Access Compliance Report Public Rights-of-Way (Curb Ramps)

Main Street: VINEYARD_RD Cross Street: ROANOKE_DR Location: SW

ADA ID: RPAT211103111757 Ramp Type: Type 1 - Perpendicular Diagonal Initial Pass/Fail: Fail Overall Compliance: No Severity Score: 0

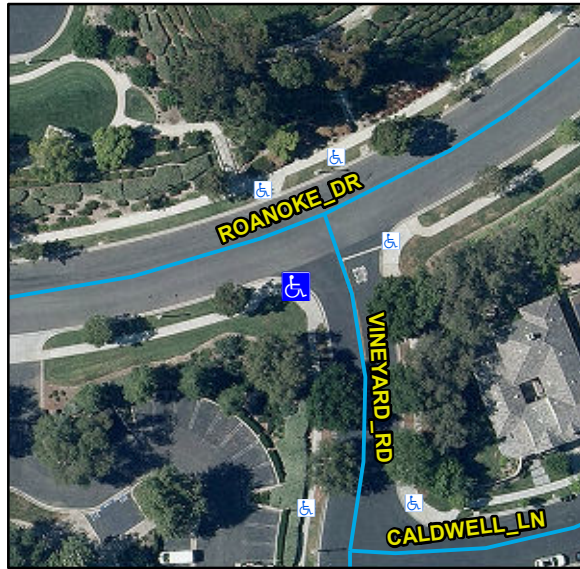
R304.2.2, R204.3, STD 1115

Remove & Replace Curb Ramp With Two New Directional Ramps or Equivalent.
